This document describes firmware changes for:

"Lynx Ion 350"

"Lynx Ion + Shunt350"

"Lynx Ion + Shunt 600"

v1.27 - 4-10-2015

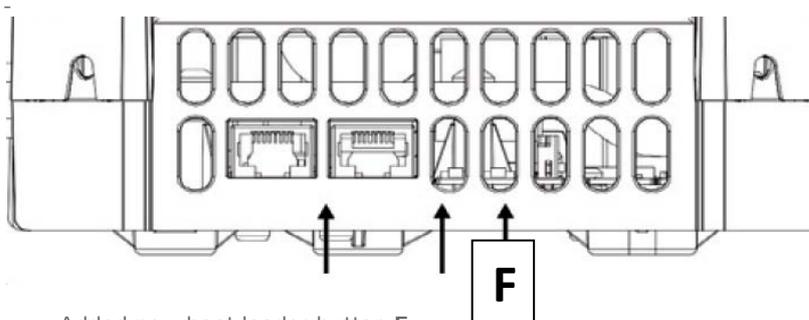
- Added new boot loader button F
If incorrect software is programmed, this button can be used to startup the boot loader again. Button can also be used to go to boot loader directly. If the device is in sleep mode and then the button is pressed for 2 seconds, device will start up in boot loader mode. This way the device is not required first to start up in normal mode.
NOTE: when device has been in boot loader mode, new software has been loaded or not, first press the Start button for 3 seconds to get it out of boot loader mode.
- Fixed bug in device settings.
- Fixed bug in history value storage.
- Updated device hardware version handling on VE-Can
- Updated charger detection, when charger detected device can also be started directly with the start button.
